Index 700-101

Typical Sections for Placement of Single and Multi-Column Signs

COMMENTS AND RESPONSES

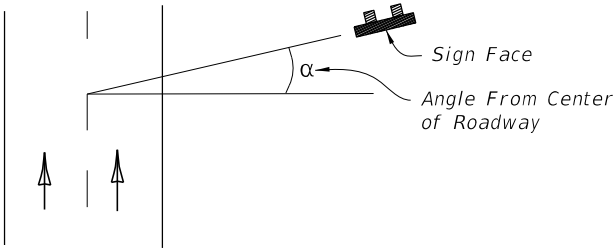
COMMENT: There appears to be a conflict with the max height of the sign over a sidewalk. In the new detail on sheet 1 of 2 for sidewalk, the height from the bottom of the sign to the ground is 9' max, however in case III on page 2 of 2, the max height is 8'.

RESPONSE: Yes, this is correct. We have updated the index to reflect an 8' maximum height.

CHANGE MADE TO INDEX: Yes.

LAST REVISION 11/01/25	REVISION	DESCRIPTION:	 FY 2026-27 STANDARD PLANS	TYPICAL SECTIONS FOR PLACEMENT OF SINGLE AND MULTI-COLUMN SIGNS	INDEX 700-101	SHEET 1 of 2
------------------------------	----------	--------------	--	--	------------------	-----------------

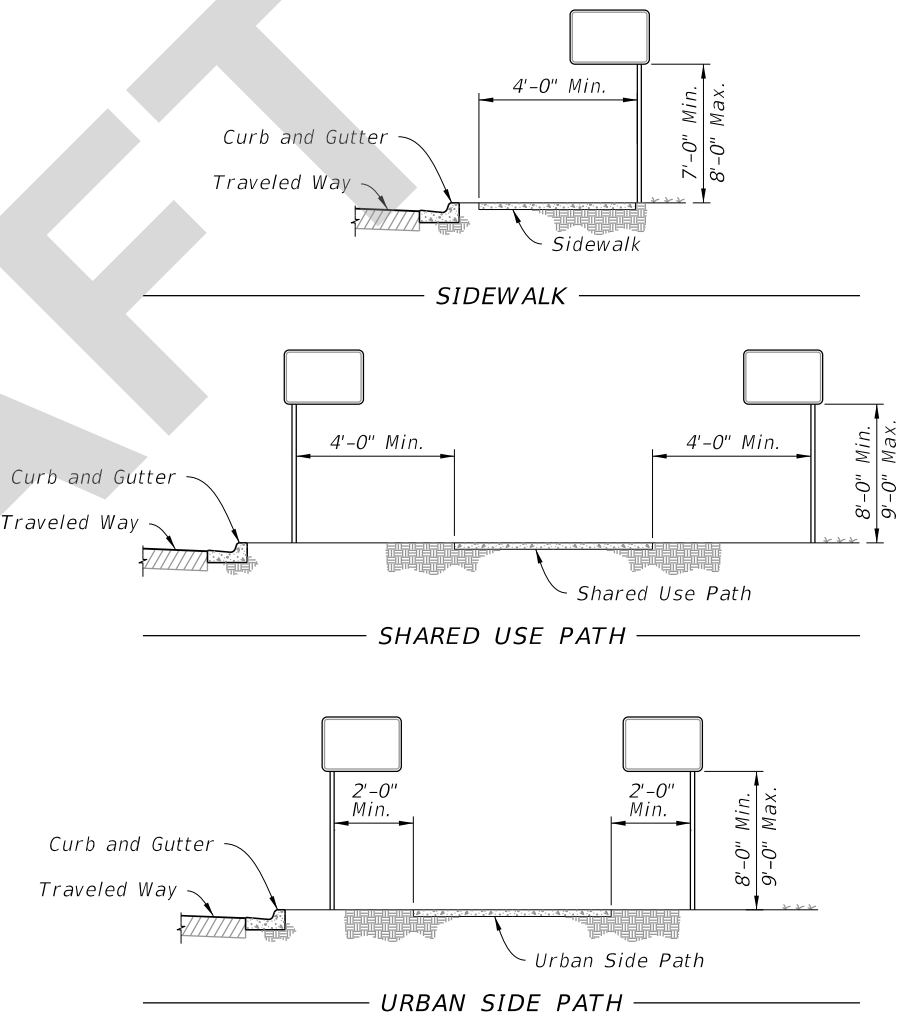
COMMENT: Under CASE X, consider revising to "See General Note 8" or "See Note 1, on sheet 1"

RESPONSE: Thank you for the comment. The callout will be changed to say "See General Note 7"

CHANGE MADE TO INDEX: Yes.
